# Addendum 01

**PROJECT:** Fort Recovery Ticket Booth and Referee Building
230 William Street
Fort Recovery, OH 45846

**PROJECT #:** 26070.00

This addendum form is a part of the Contract Documents and modifies the Construction Documents dated October 28, 2026, with amendments and additions noted below.

SHEET NUMBER:
**LD1.1**

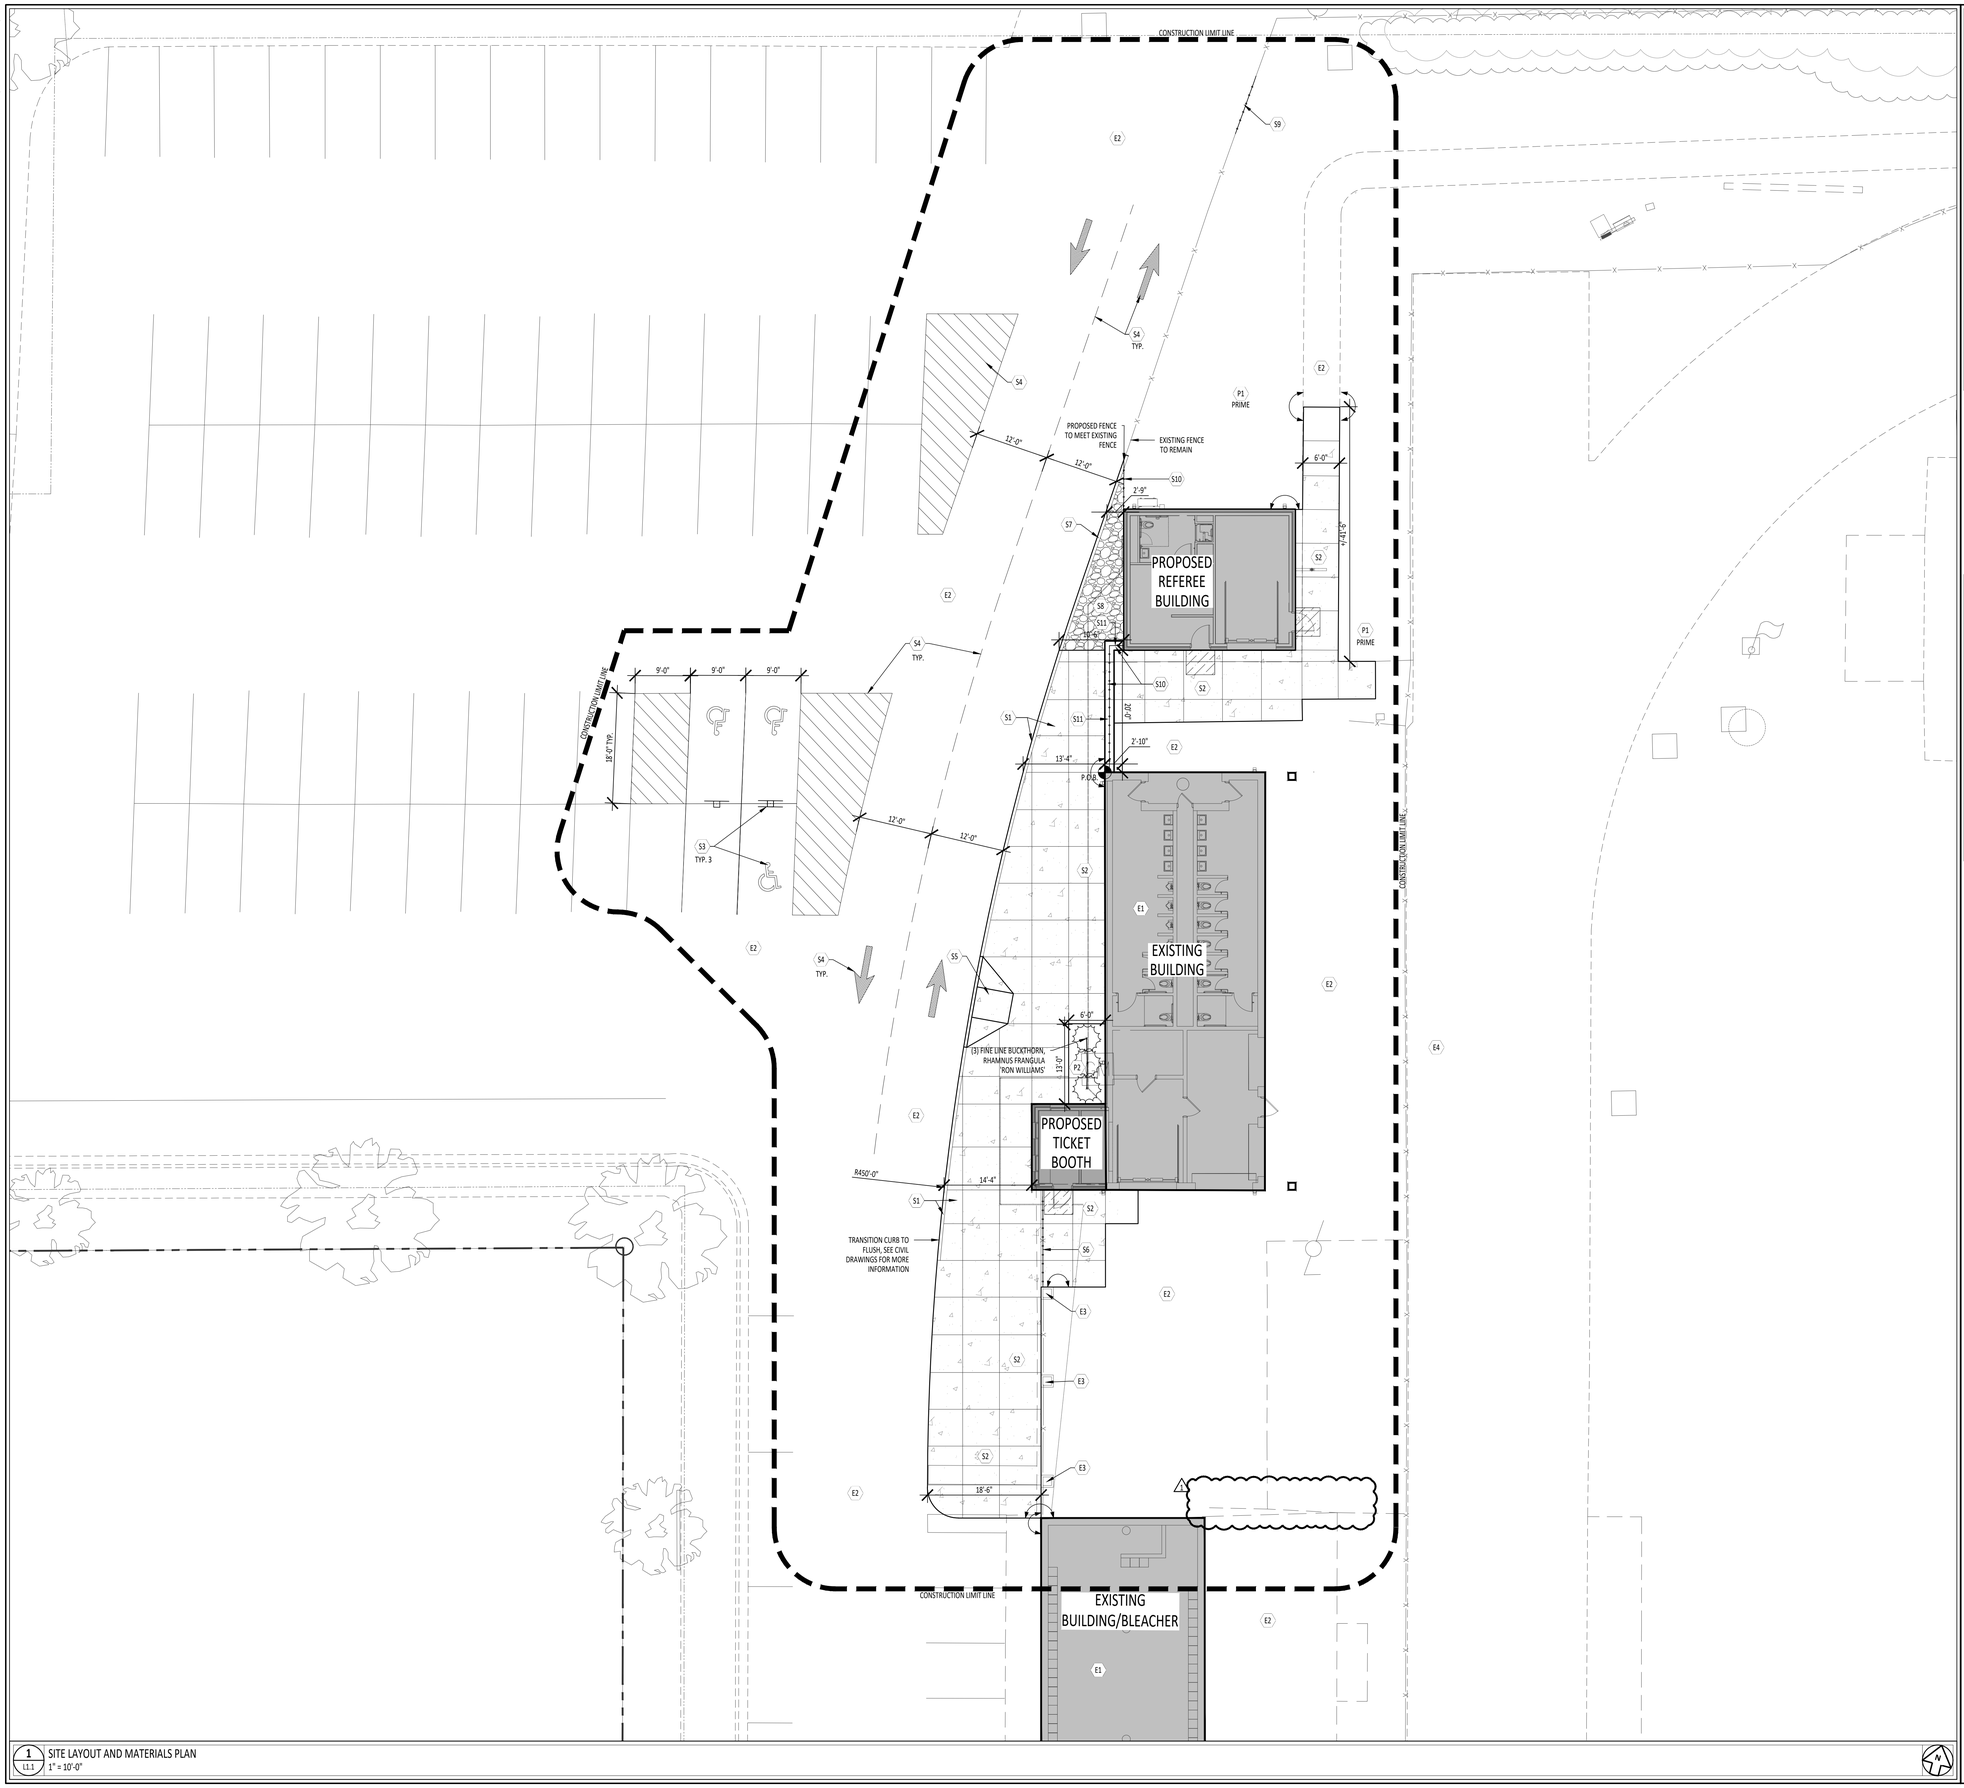
a. Updated to correct address.
   b. Added word 'sawcut' to notes D2 and D3
   c. Revised note D3 to read: Remove and salvage fence posts and fence for re-installation.

i. See site plan for location of this work
   d. Added note D10 – Remove masonry column and associated foundation
4. Sheet L1.1 – Site Layout and Materials Plan

**SITE LAYOUT AND MATERIALS PLAN**

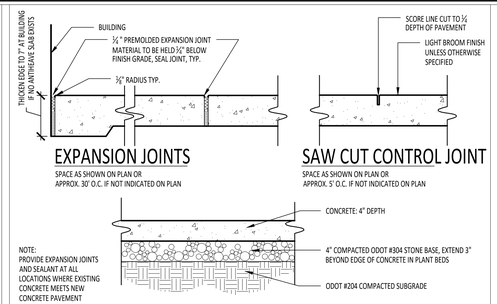
a. Updated to correct address.
   b. Note S11: added 'and see civil drawings for grading information' to the note.
   c. Removed an S6 note from the plan, reference revised drawing for bubbled area.

SHEET NUMBER:
**A0.1**

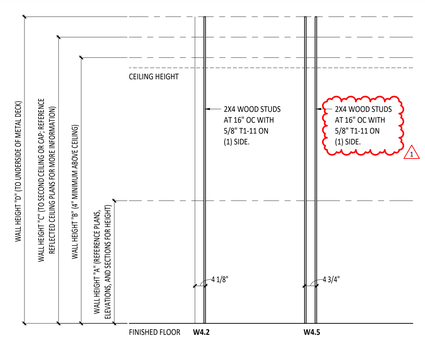
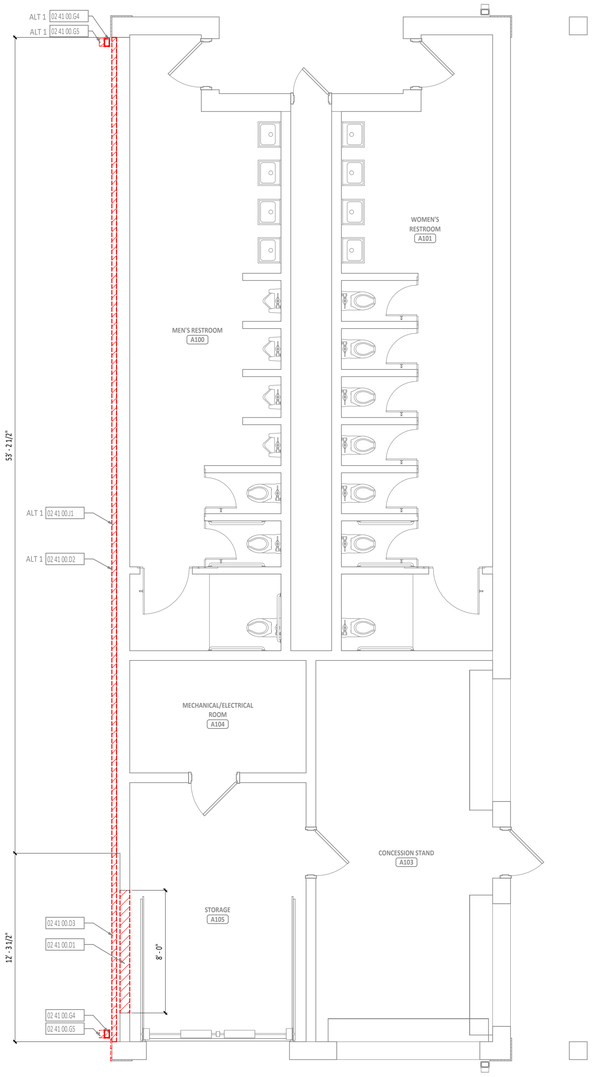
b. Changed metal stud to wood stud in W4.5 wall type.
7. Sheet AD1.1 – First Floor Demolition Plan and Reflected Ceiling Demolition Plan
   a. Updated to correct address.

SHEET NUMBER:
**A1.1**

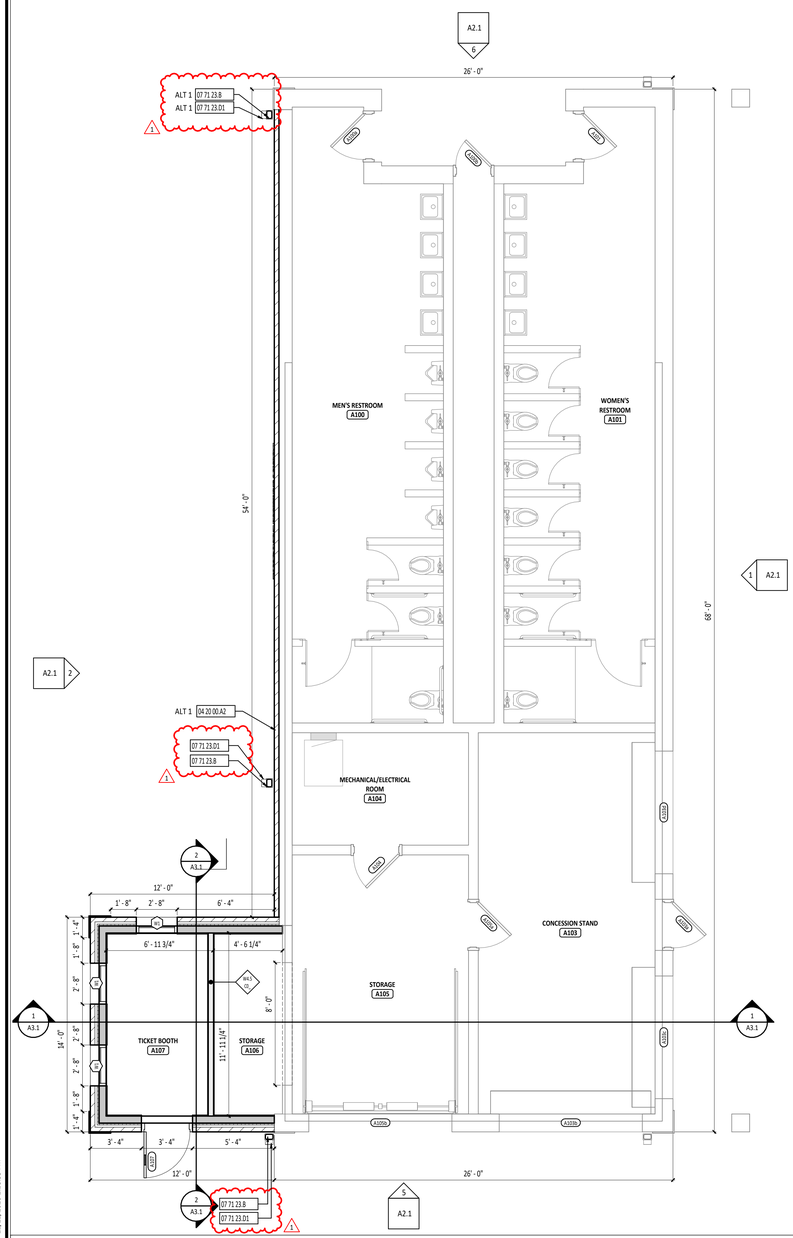
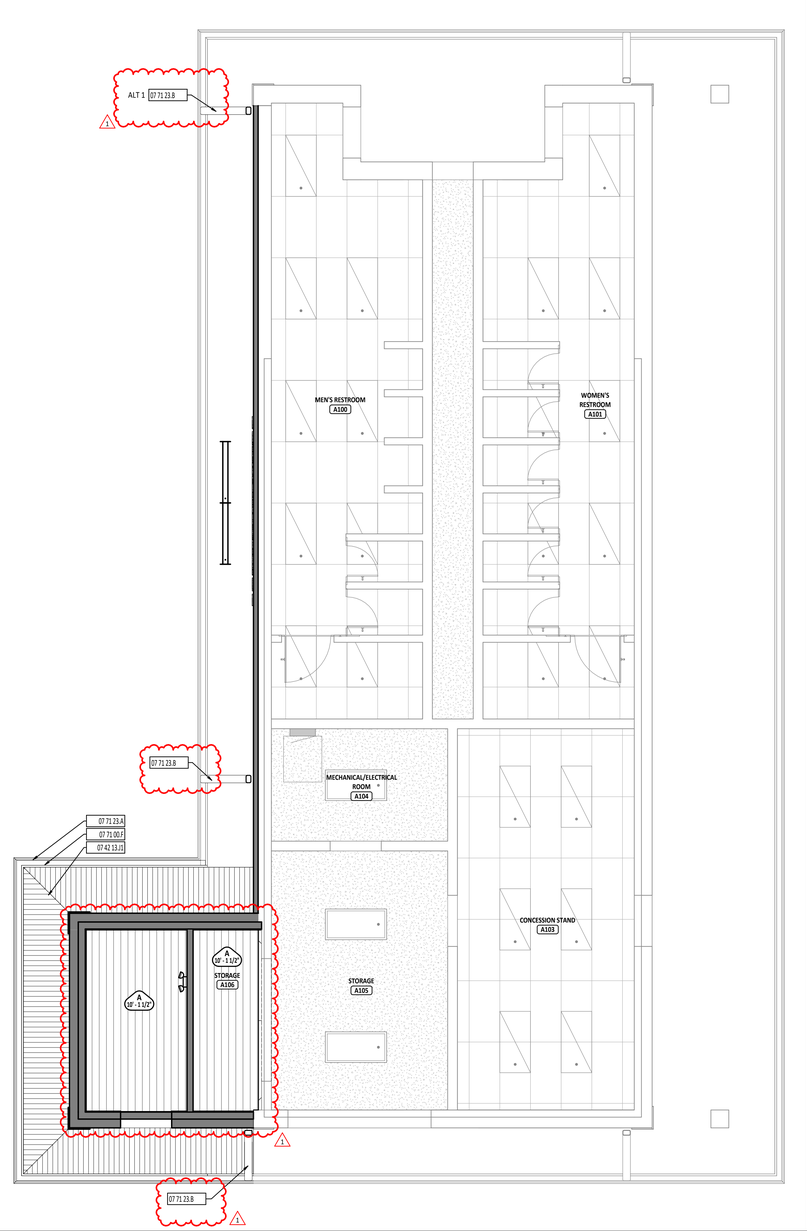
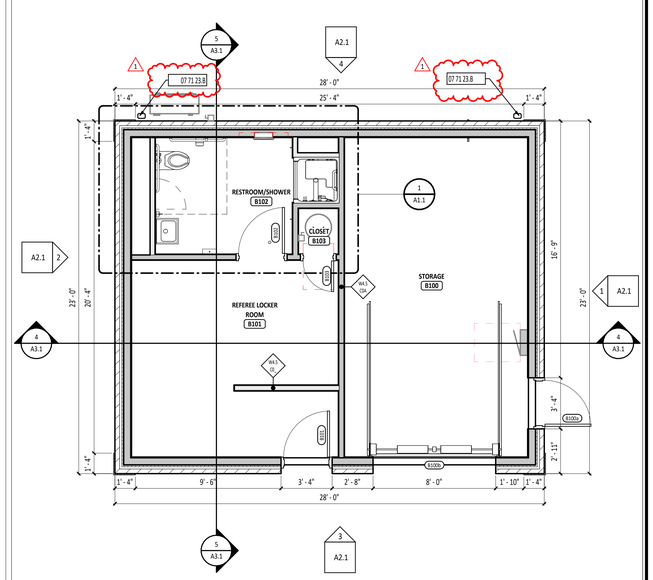
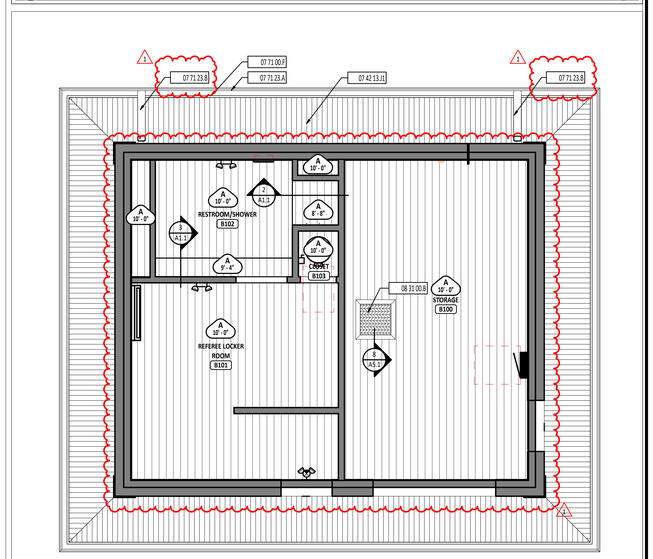
8. Sheet A1.1 – First Floor Plan, Reflected Ceiling Plan and Enlarged Restroom Plan
   a. Updated to correct address.
   b. Updated prefinished downspout keynote description to match existing.

c. Added 1x trim – painted along ceilings.
   d. Updated toilet accessory number TA3.2 to TA3.1, and TA9.4 to TA6.1.
   e. Adjusted wall bearing height on referee building to 10'-0" and locker room addition to 10'-1 1/2"

**BUILDING ELEVATIONS**

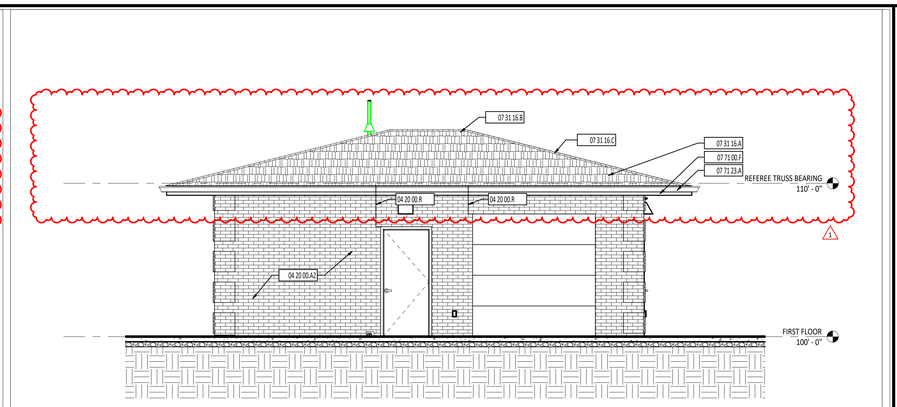
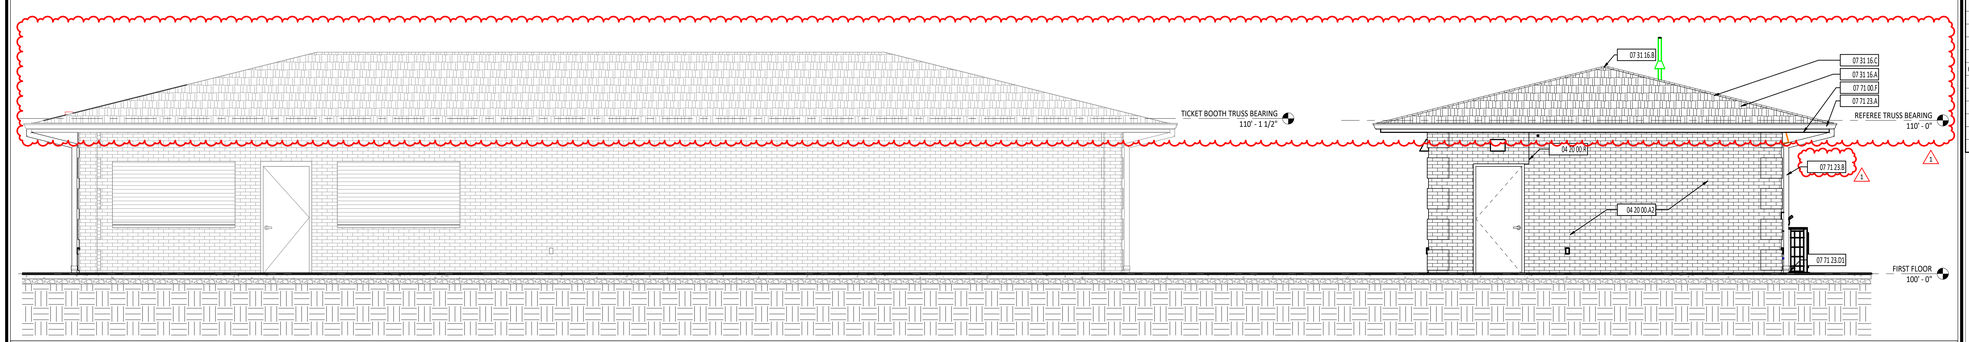
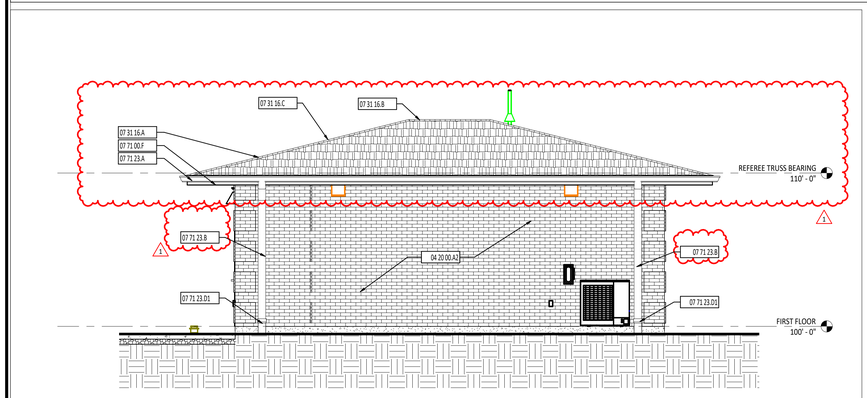
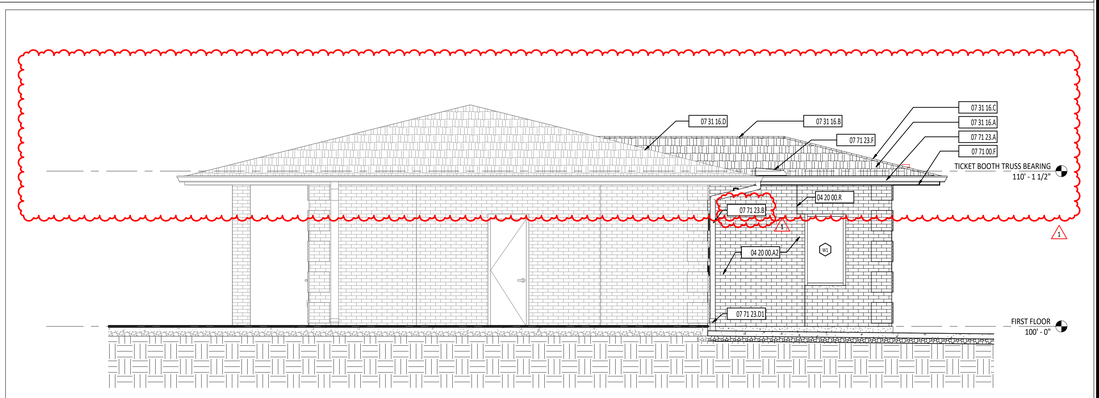
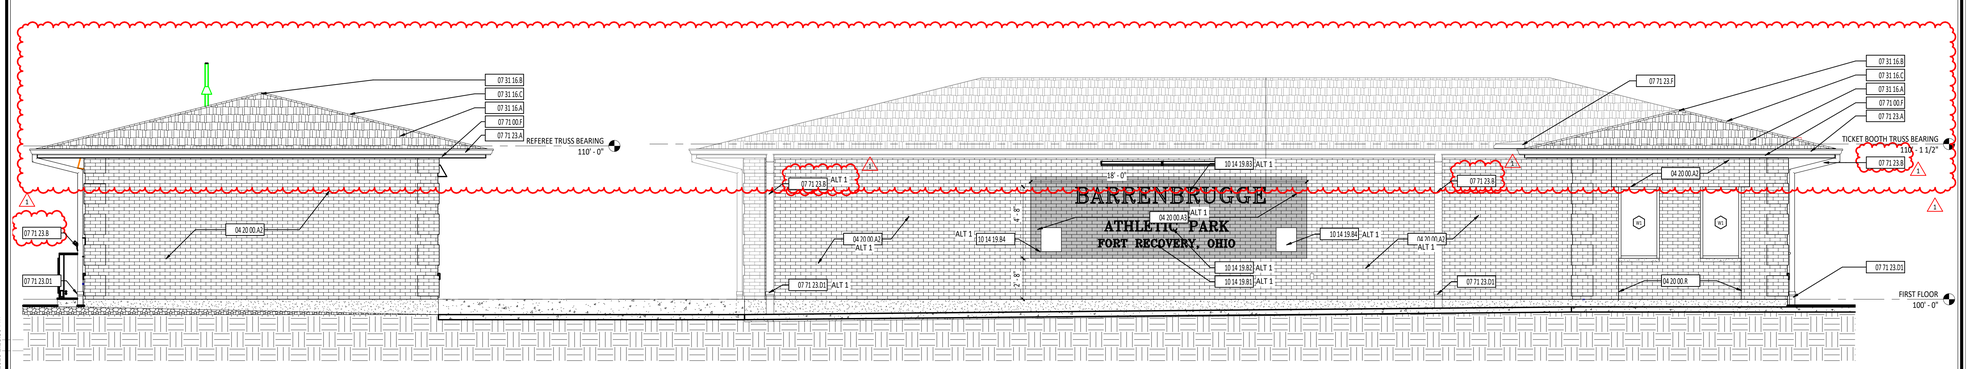
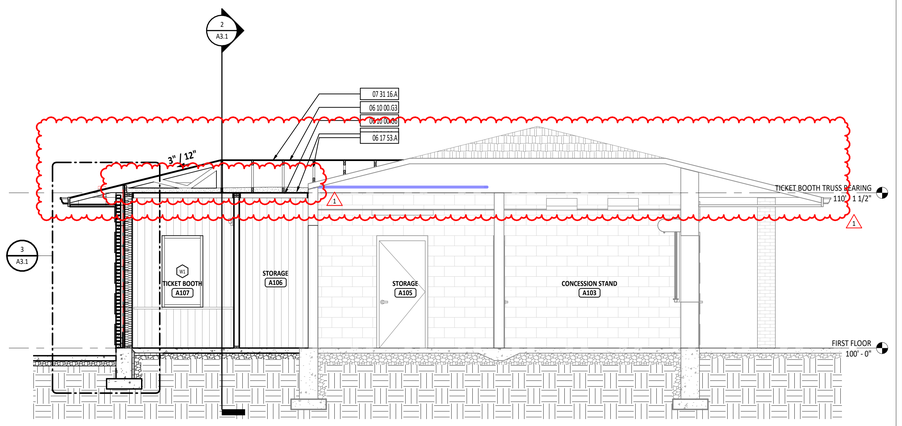
9. Sheet A2.1 – Building Elevations
   a. Updated to correct address.
   b. Updated prefinished downspout keynote description to match existing.
   c. Adjusted wall bearing height on referee building to 10'-0" and locker room addition to 10'-1 1/2"

- Q: **Cast Stone Masonry –** Detail 14/A6.1 refers to cast stone masonry sills, but the building elevations don't show any; should there be cast stone sills?
- A: Yes, there will be cast stone sills. Will be added to elevations in addendum 01.
